ADDENDUM NO. 3

RE: Downtown East Drainage Improvements – City of Stuttgart, Arkansas

ADDENDUM DATE: April 19, 2024

Sheets Revised: The following plans sheets have been revised and are attached to this addendum. These sheets are to be replaced in the overall sheet set. **Sheets 45-47 & 50-57.**

STORM PLAN
 5TH STREET

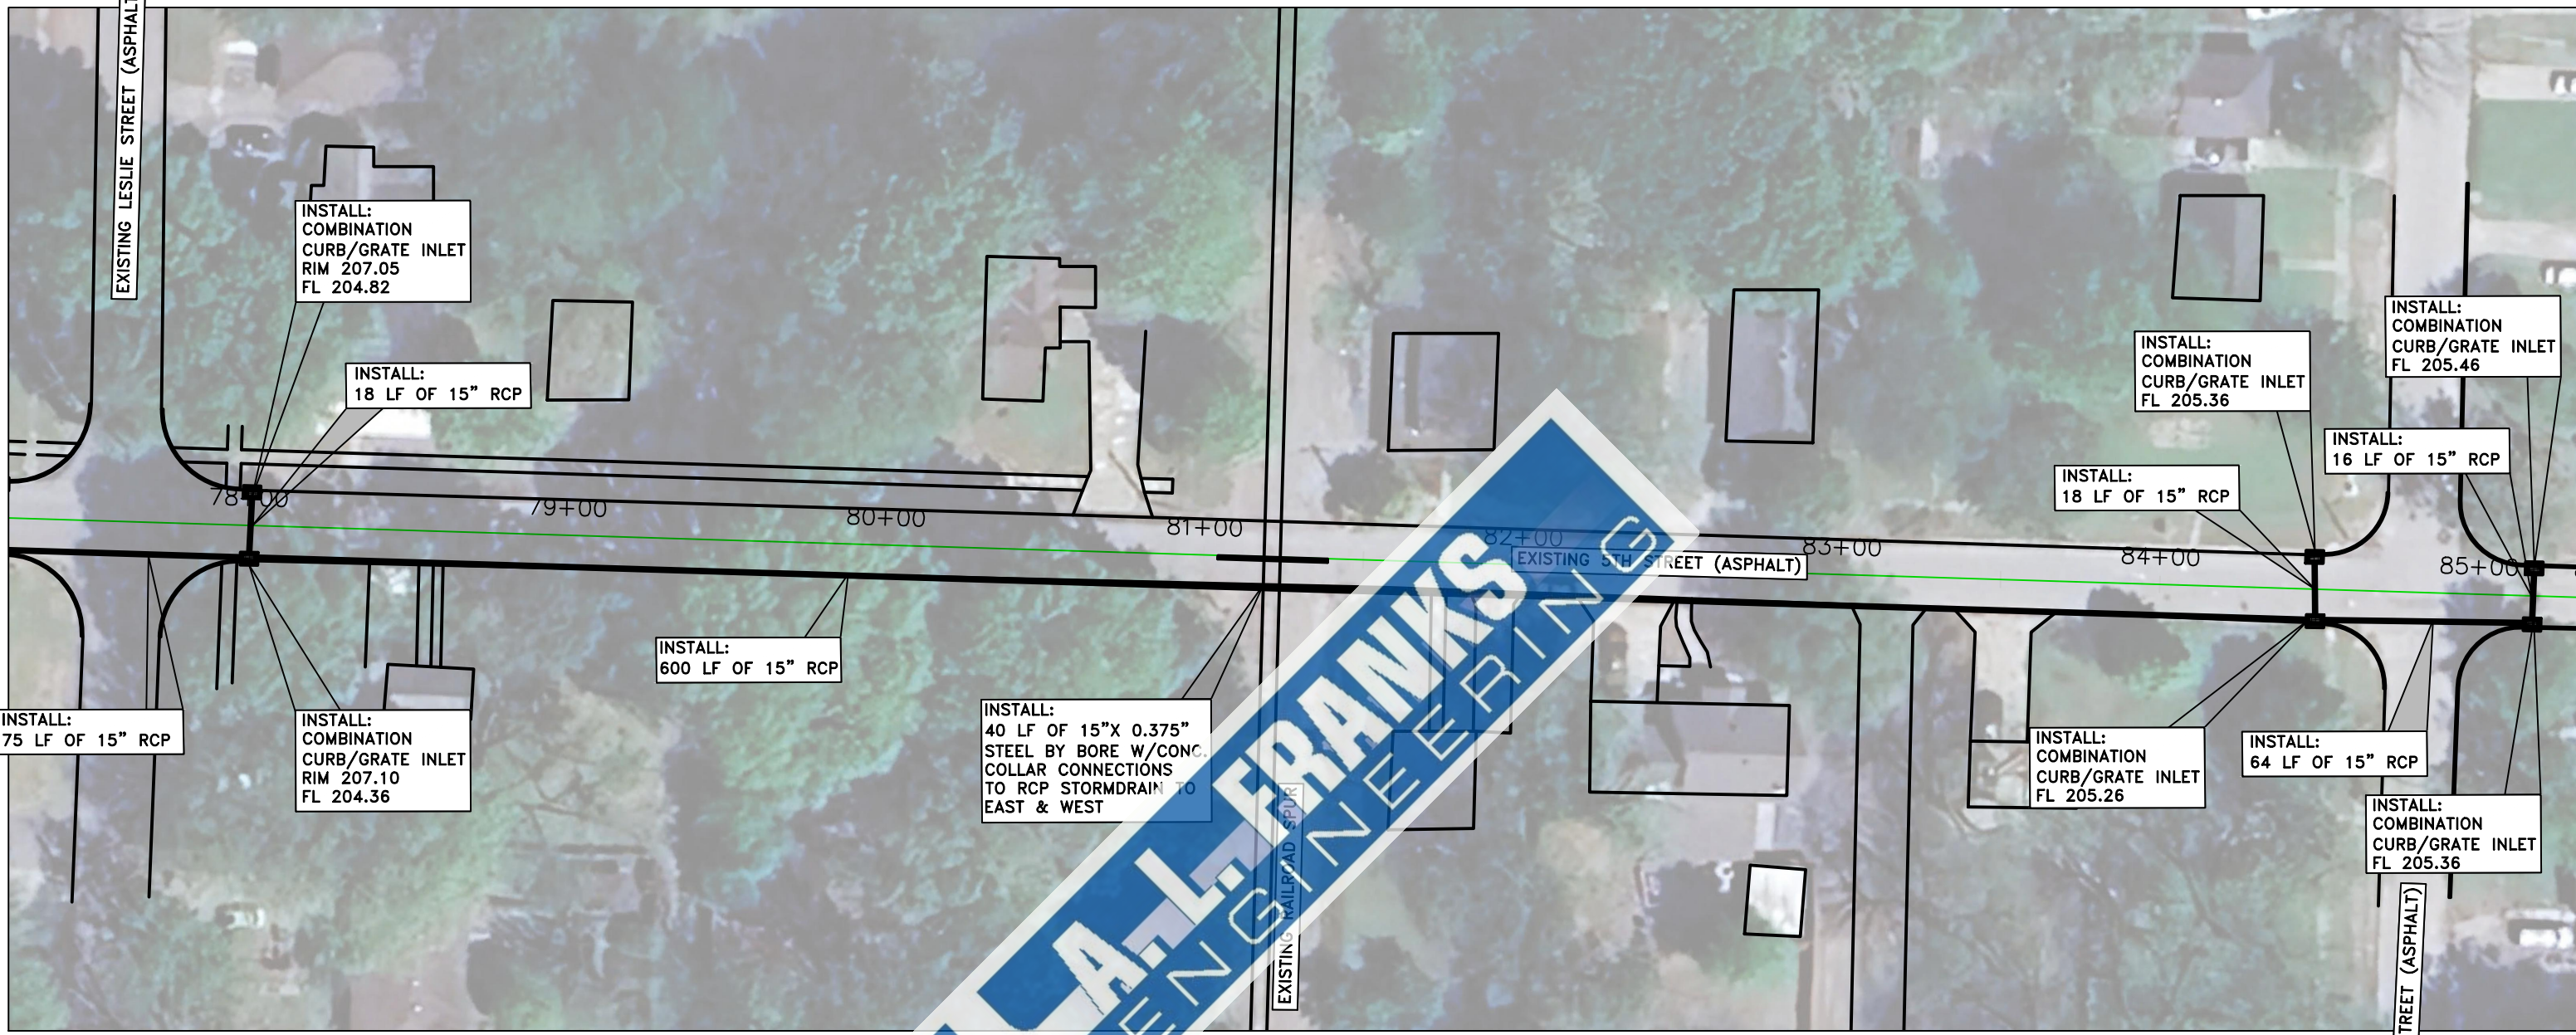
Date	Revision	By
4/18/24	1-Additional elevation data added	CJM

STORM PLAN
 6TH & ANNA STREET

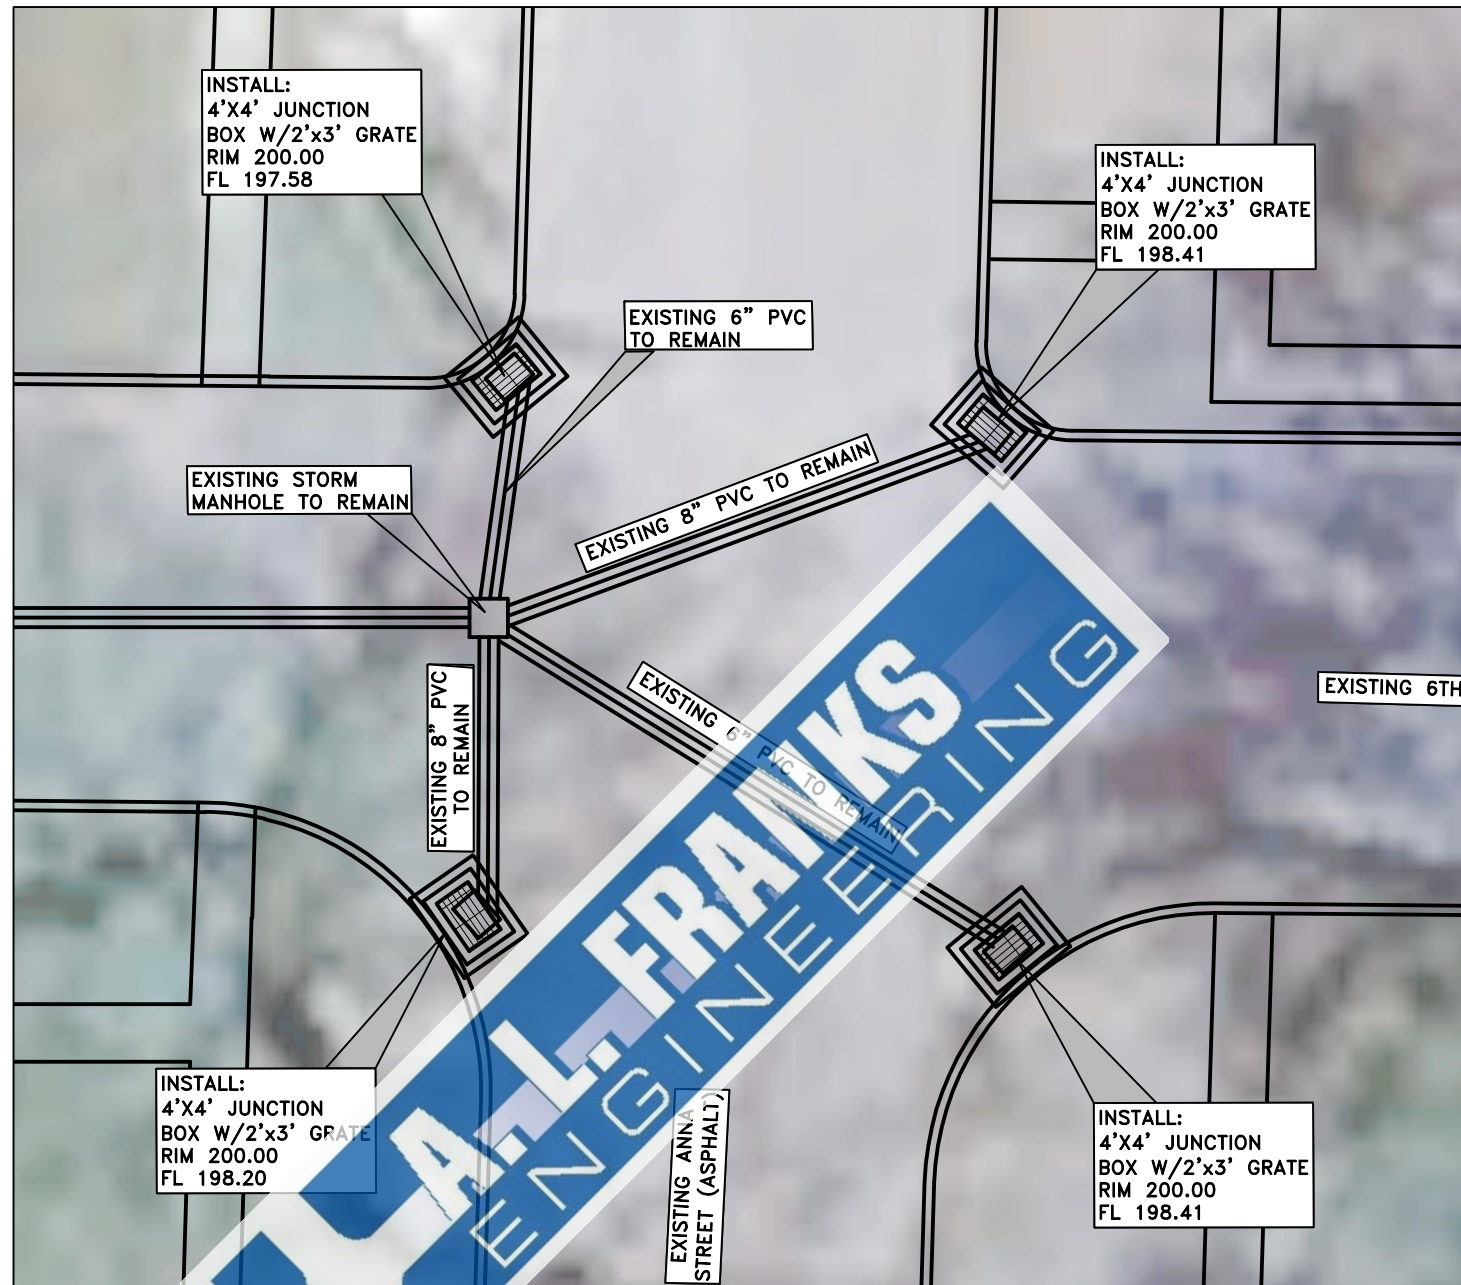
Date	Revision	By
4/18/24	1-Additional elevation data added	CJM

STORM PLAN
 7TH STREET

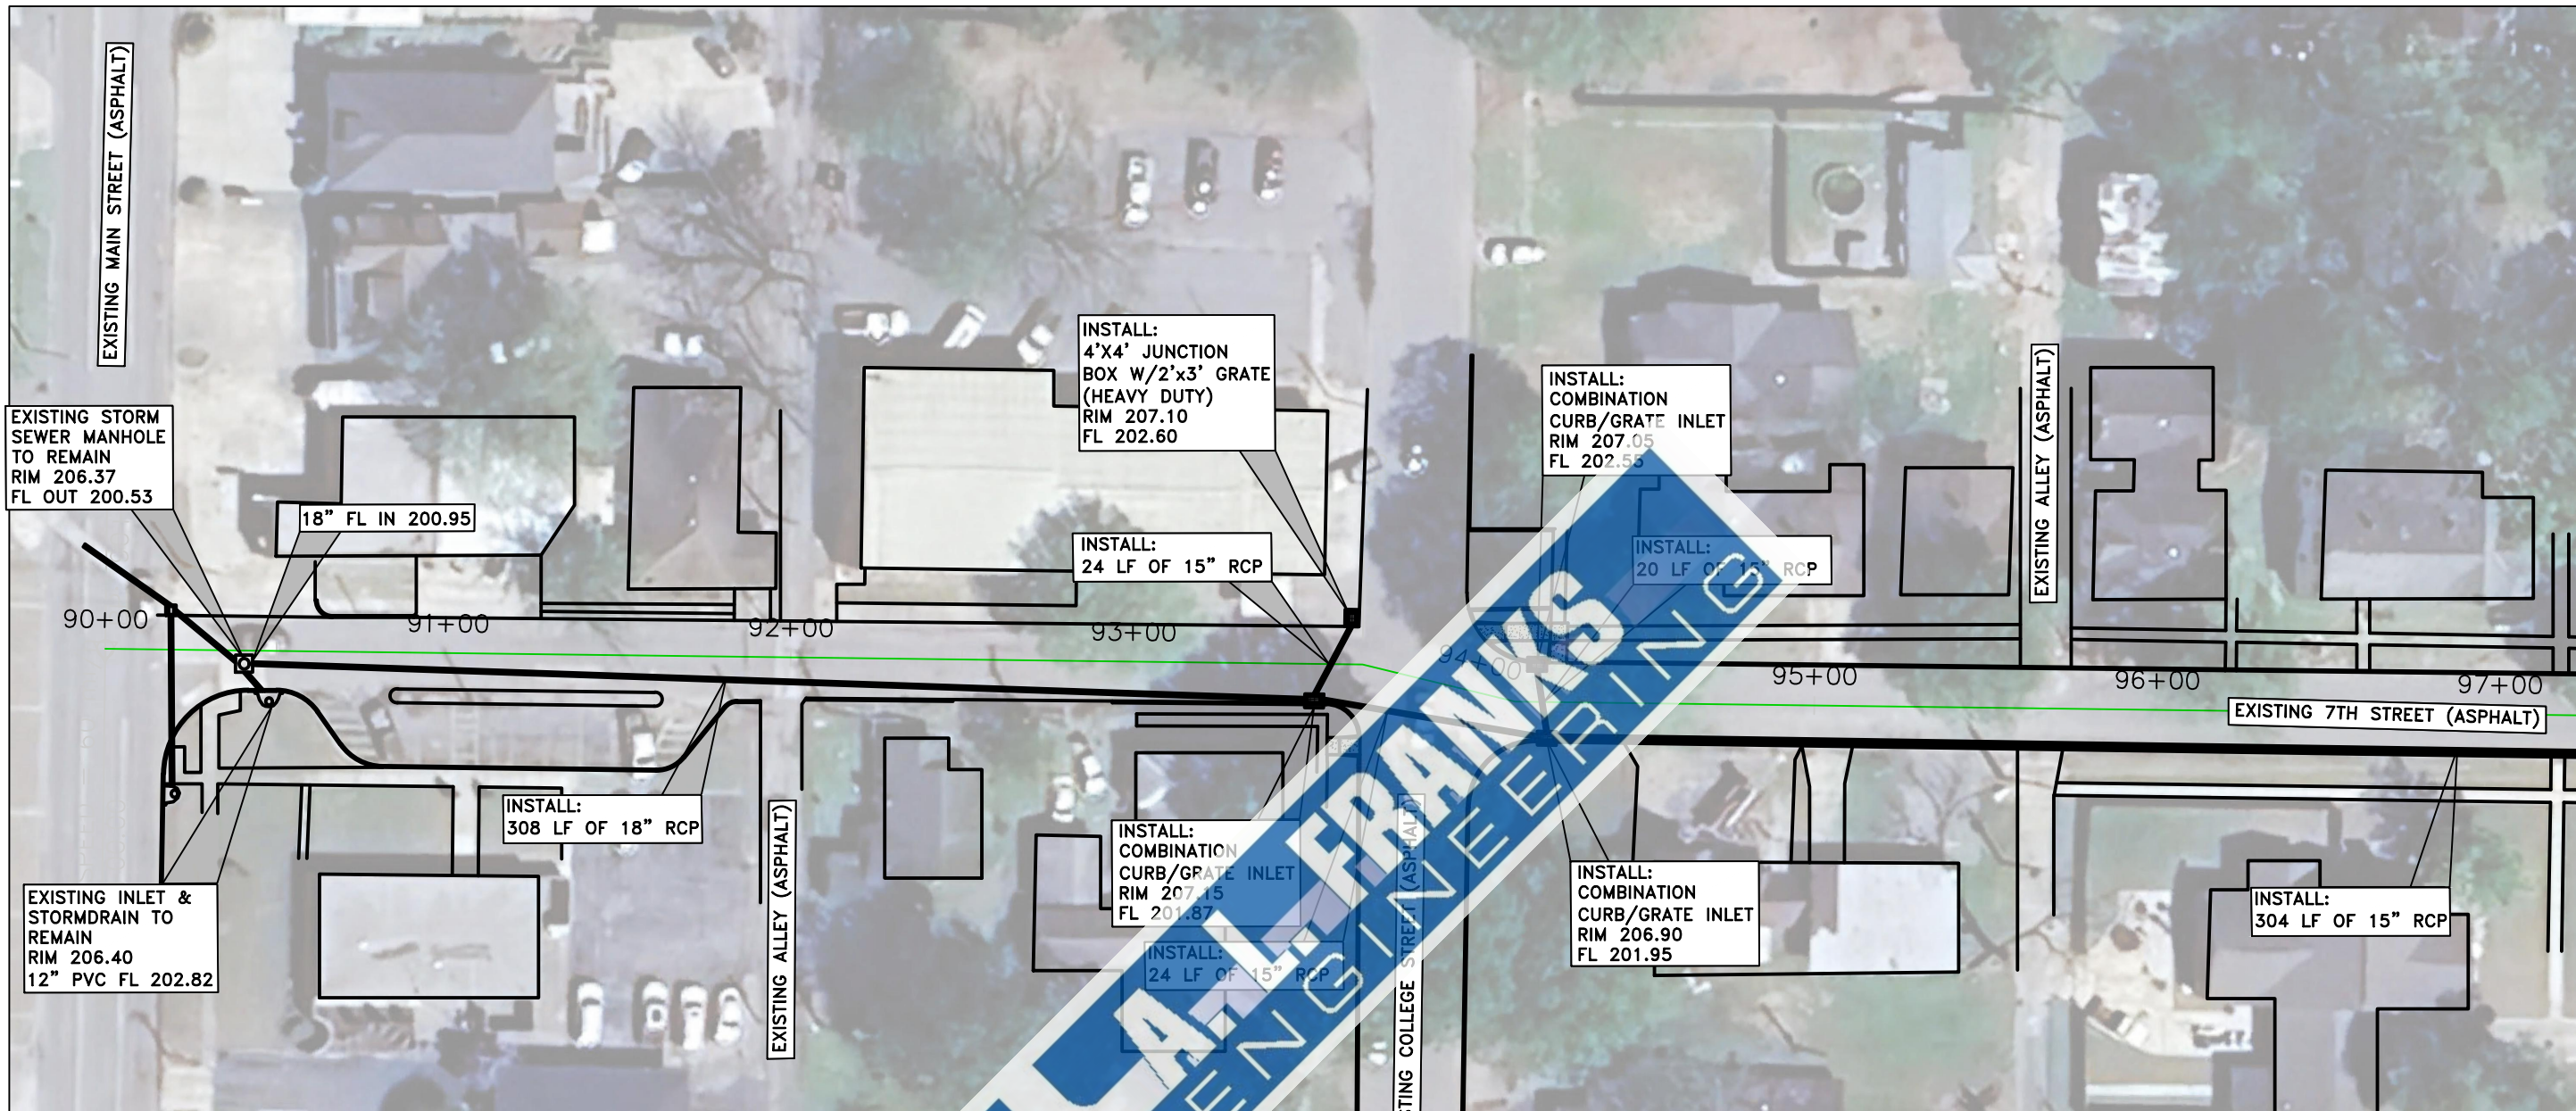
Date	Revision	By
4/18/24	1-Additional elevation data added	CJM

STORM PLAN
 7TH STREET

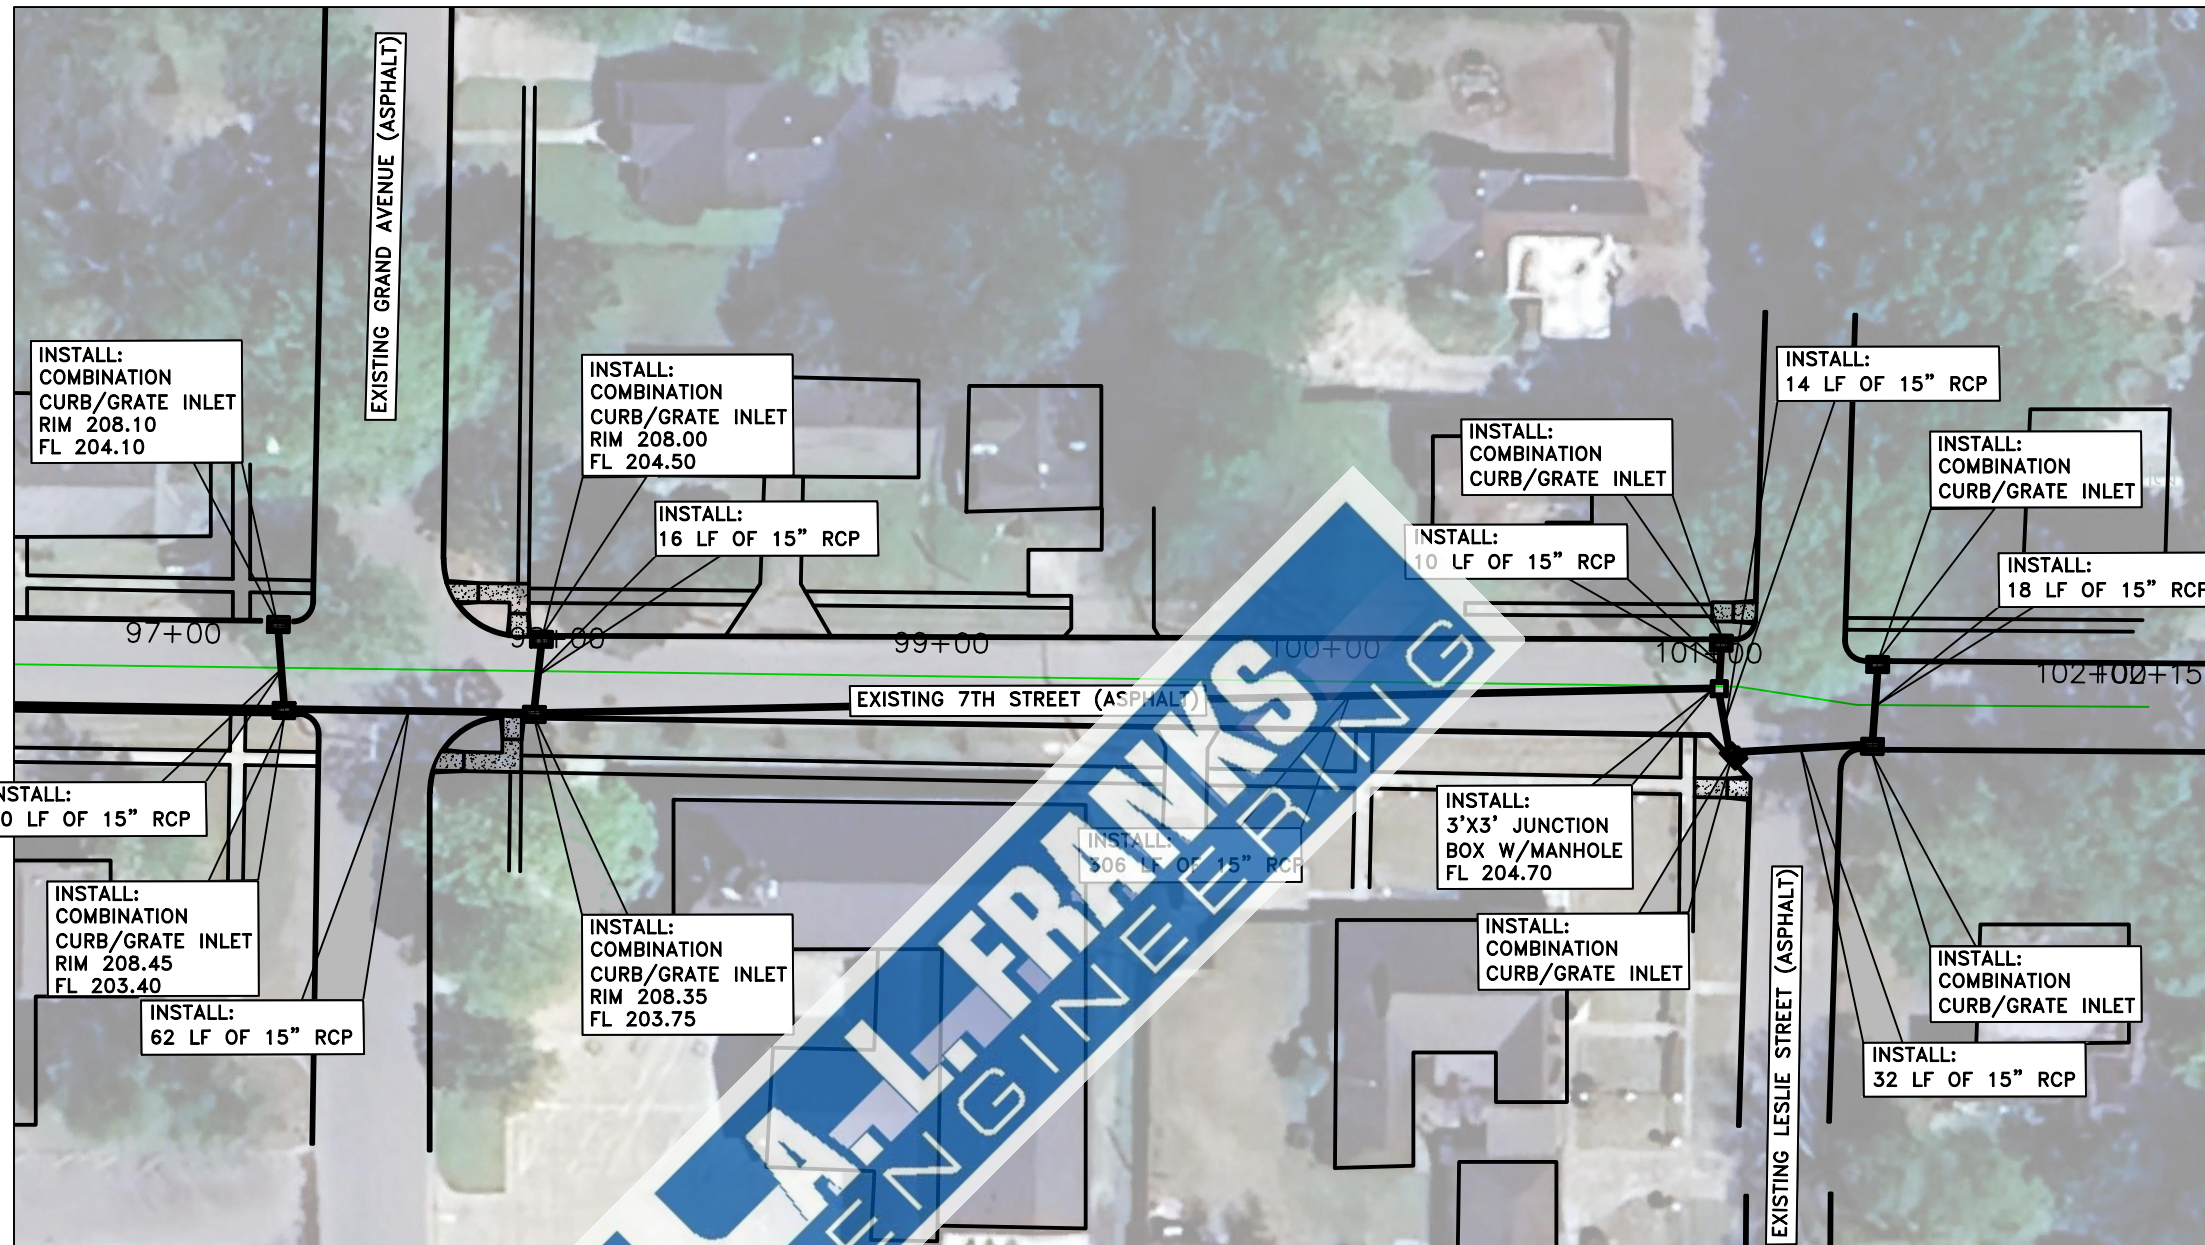
Date	Revision	By
4/18/24	1-Additional elevation data added	CJM
